# Detailed Site Plan Central Industrial Park

## DSP-23020

STAFF REPORT

SUBJECT: Detailed Site Plan DSP-23020  
Central Industrial Park

Figure 1: Detailed Site Plan

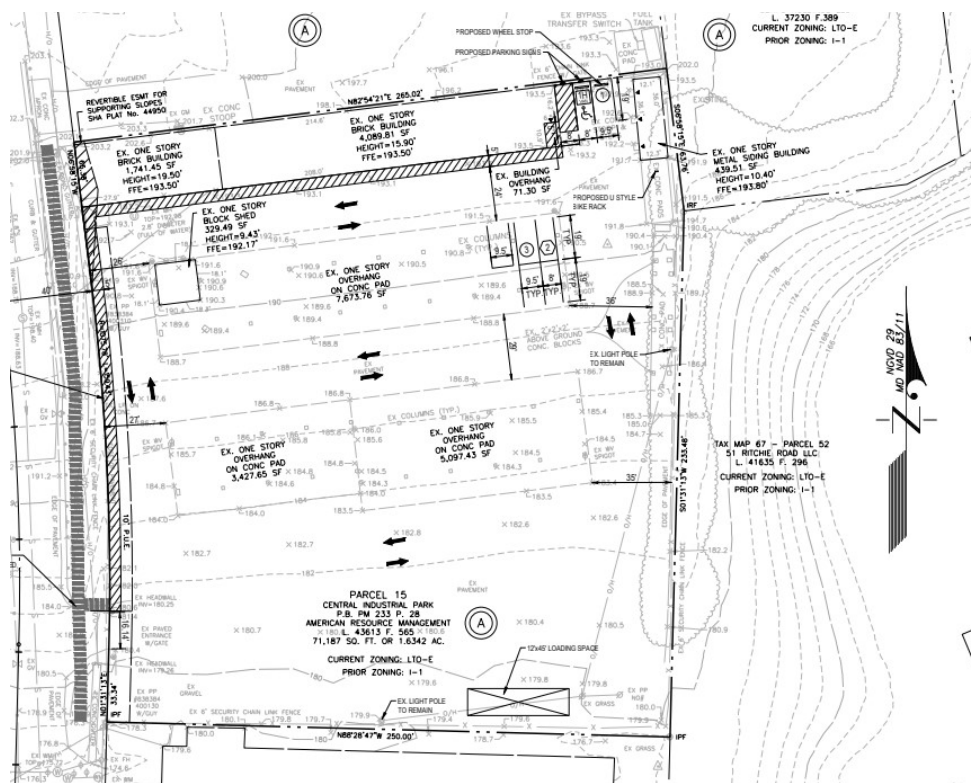
The only proposed site improvements include one new bike rack and the striping of a pedestrian pathway and seven proposed parking spaces (one handicap van-accessible, four standard, and two compact).

- c. **Subdivision**—In a memorandum dated January 28, 2025 (Vatandoost to Cofield), the Subdivision Section noted that the DSP has been found to be in conformance with the approved PPS and ADQ. All bearings and distances must be clearly shown on the DSP, and must be consistent with the record plat, once it is approved, or permits will be placed on hold until the plans are corrected.

- 1. Prior to certificate approval of this detailed site plan, the applicant shall:
  - a. Revise the plan to include a required and provided parking schedule on the site plan.
  - b. Provide standard general notes on the site plan, as indicated below:
    - (1) Existing uses.
    - (2) Existing green area.
  - c. Label the height on the existing canopies.
  - d. Label the proposed pedestrian pathway.

- e. Label the setbacks for all existing buildings.
- f. Revise the street connection driveway to a minimum 22 feet wide.
